Access Compliance Report

Public Rights-of-Way

(Curb Ramps)

Intersection ID: 19313	Main Street: RANDOLPH_RD	Cross Street: SARDIS_RD	Location:	W
ADA ID: 209BDA73DDA9	Ramp Type: Perp	Initial Pass/Fail: Fail	Overall Compliance: No	Severity Score: 25
Codes/Mitigation Info/Possible Solution		Field Measurements/Component Compliance

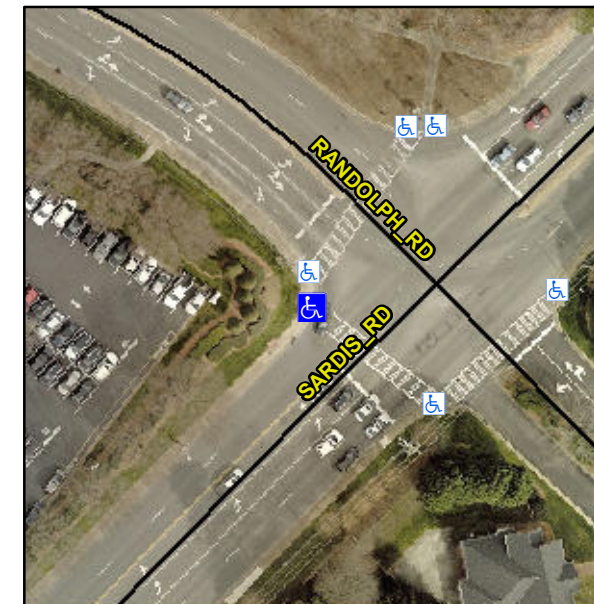
Not Found, R304.2.2, R304.5.3

Compliance	Description	Data	Compliance	Description	Data
N/A	Ramp Length (in)	65.0	No	Ramp Slope (%)	8.4
Yes	Ramp Width (in)	48.0	No	Ramp XSlope (%)	5.8
N/A	Flare Type LT	N/A	N/A	Flare Type RT	N/A
N/A	Flare Slope LT (%)	N/A	N/A	Flare Slope RT (%)	N/A
N/A	Flare Traversable LT?	N/A	N/A	Flare Traversable RT?	N/A
N/A	Landing Length (in)	N/A	N/A	DWS Provided?	N/A
N/A	Landing Width (in)	N/A	N/A	DWS Contrast?	N/A
N/A	Landing Slope (%)	N/A	N/A	DWS Length (in)	N/A
N/A	Landing X Slope (%)	N/A	N/A	DWS Full Width?	N/A
N/A	Landing Curb? (Y/N)	N/A	N/A	DWS Offset (in)	N/A
N/A	Shared Landing?	N/A			
N/A	Gutter Ponding?	N/A	N/A	Gutter Slope (%)	N/A
N/A	Gutter Lip Ht (in)	N/A	N/A	Gutter X Slope (%)	N/A
N/A	Painted X Walk1?	Yes	N/A	Painted X Walk2?	N/A
	X Walk 1 Direction	To SE		X Walk 2 Direction	N/A
N/A	X Walk 1 Width (in)	108.0	N/A	X Walk 2 Width (in)	N/A
	X Walk 1 Slope (%)	7.0		X Walk 2 Slope (%)	N/A
	X Walk 1 X Slope (%)	0.8		X Walk 2 X Slope (%)	N/A

Remove & Replace Entire Ramp.
